PLANNING & ZONING DEPARTMENT
Before the Planning & Zoning Commission
Meeting of 25 February 2025

CONSENT AGENDA ITEM
STAFF REPORT

Final Plat Approval for Kinghorn Place No 4 Subdivision in a RS7 (Single Family Residential) zoning district, a 12.49 acre parcel #R435600000 addressed as 0 Northside Blvd, located in the SE 1/4 of S33, T4N, R2W, BM, for Kent Brown representing Corey Barton (SPF-00281-2025).

Sheet 2

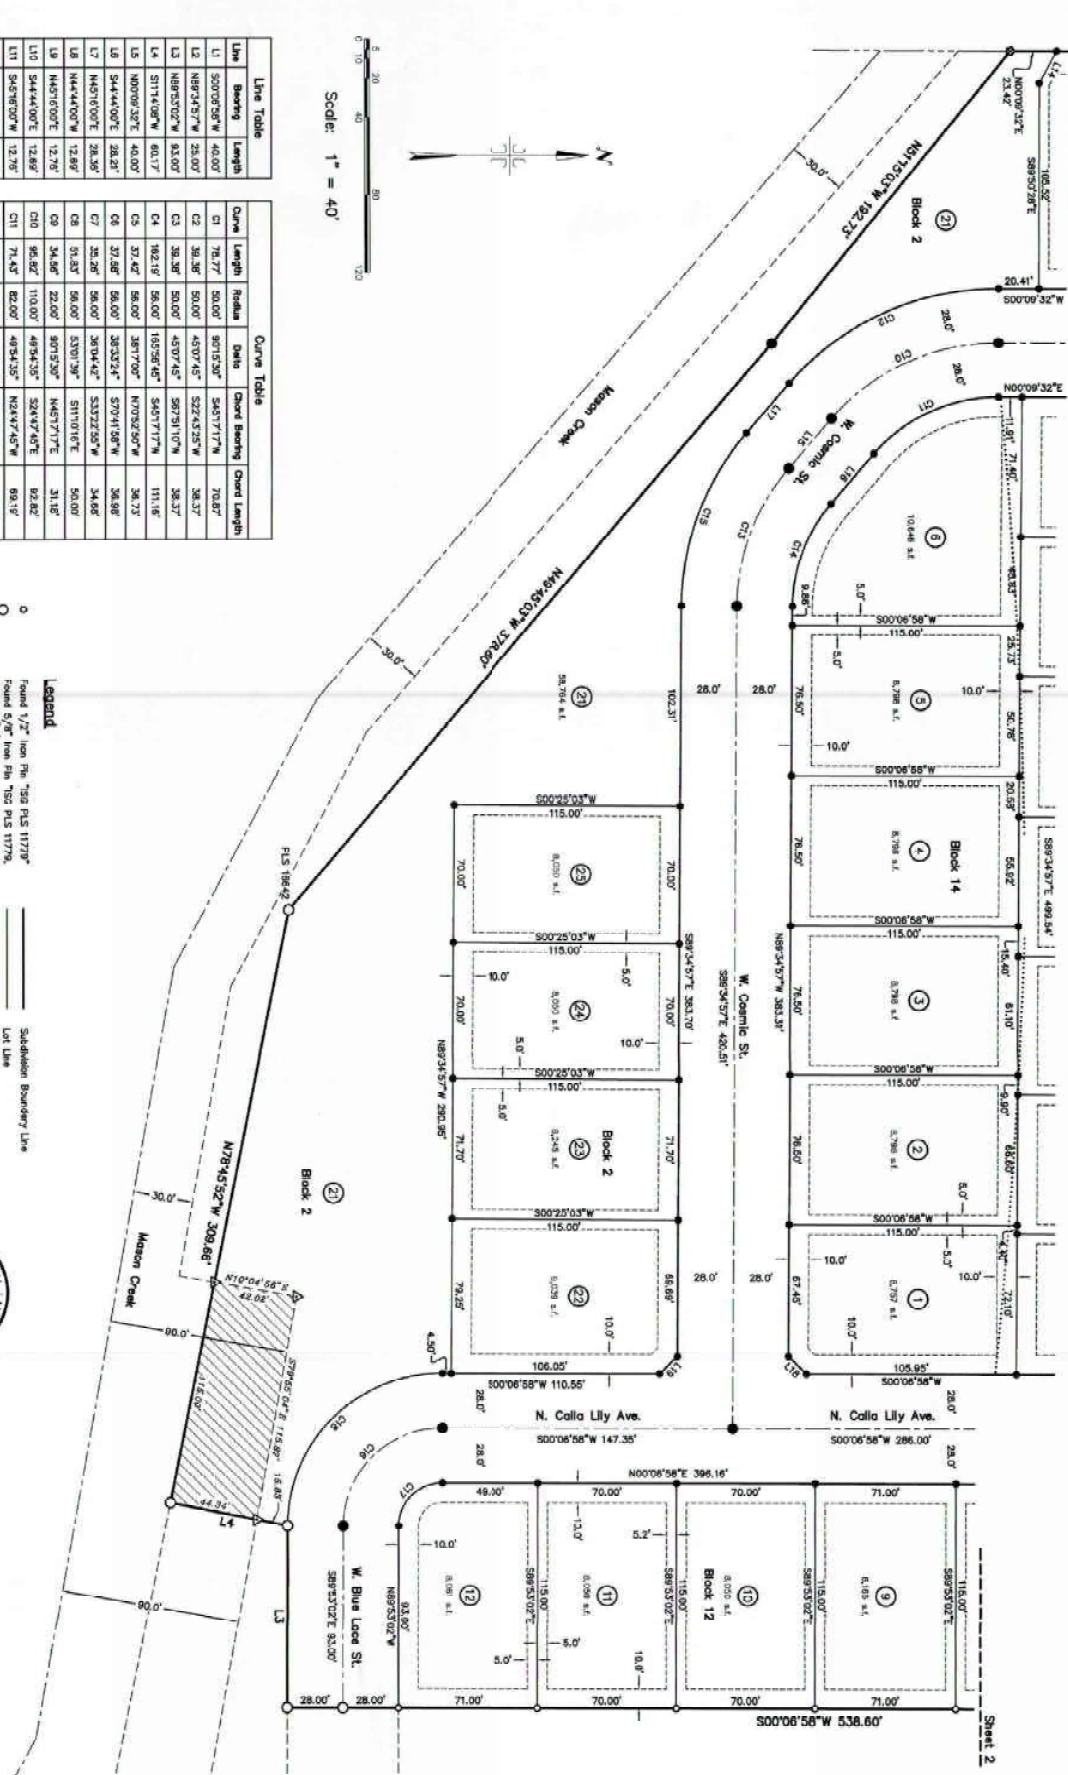
1. Fill in book/page numbers for Kinghorn Place Subdivision No. 1 and No. 2.
2. Note which lots are "in-fill" lots with areas less than 7,000-sf.
3. Note public pathway easement to be created on Lot 21, Block 2.

LANDSCAPE PLAN
REVISIONS REQUIRED

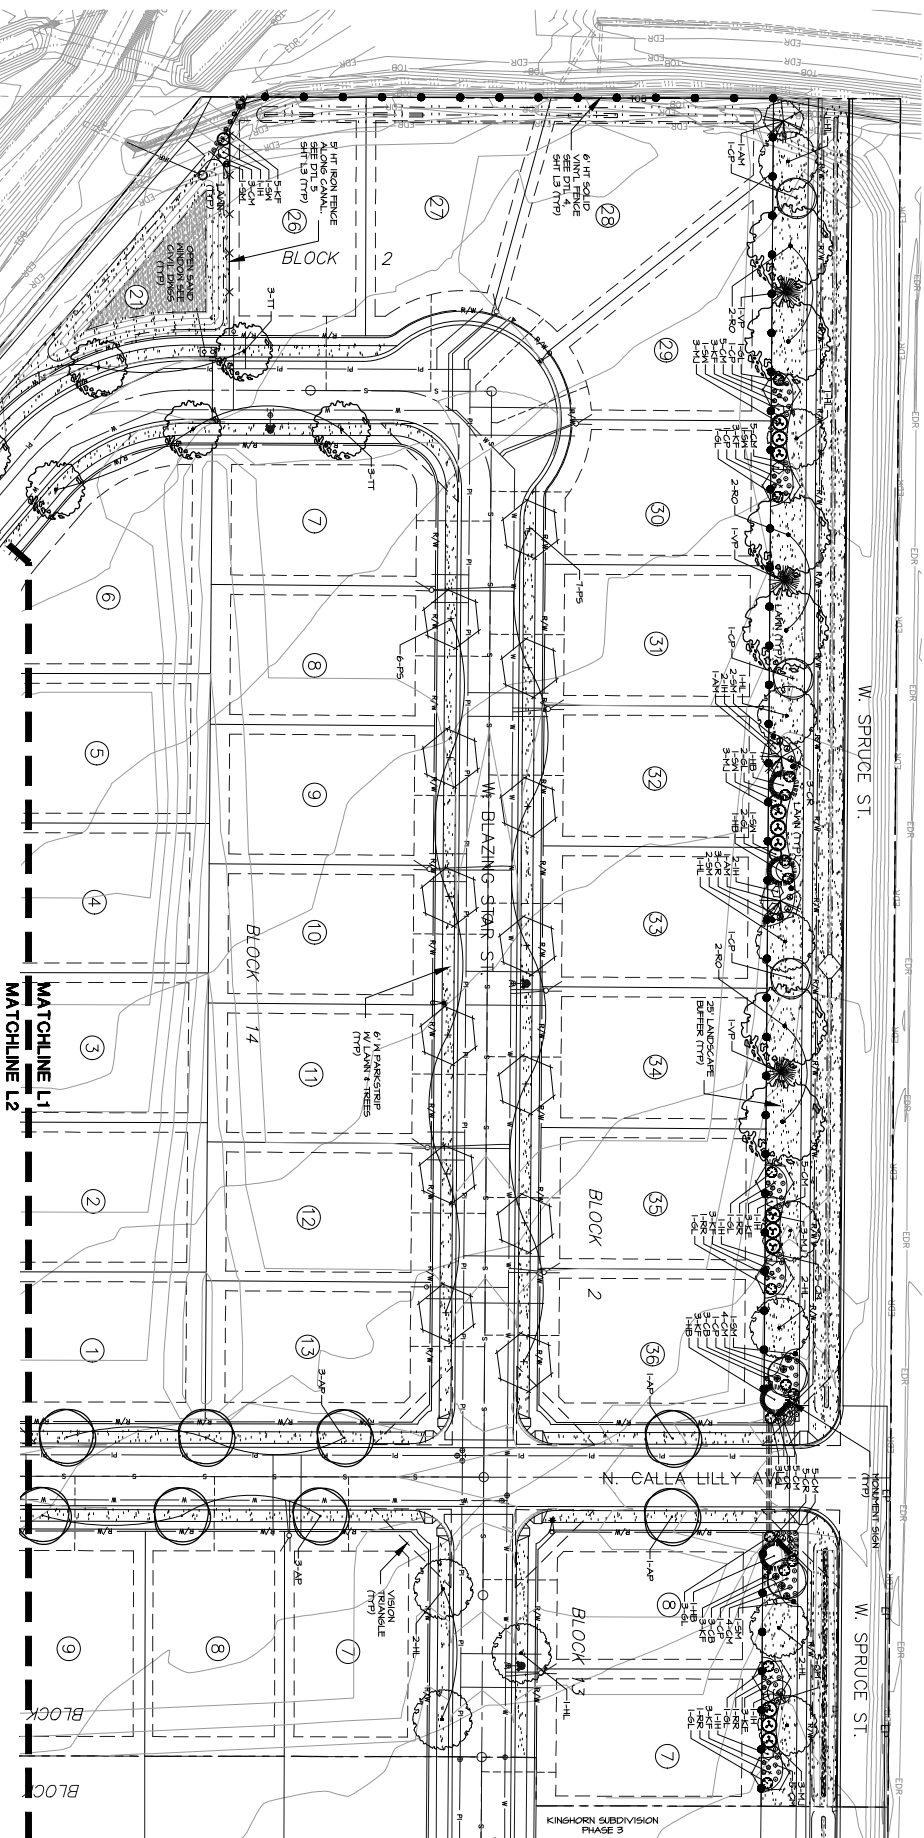
The architect/developer to select an alternative tree for the Autumn Purple Ash. This tree has a known pest currently causing destruction and another known pest that has devastated Ash trees across the country but has not been discovered in Idaho, yet.
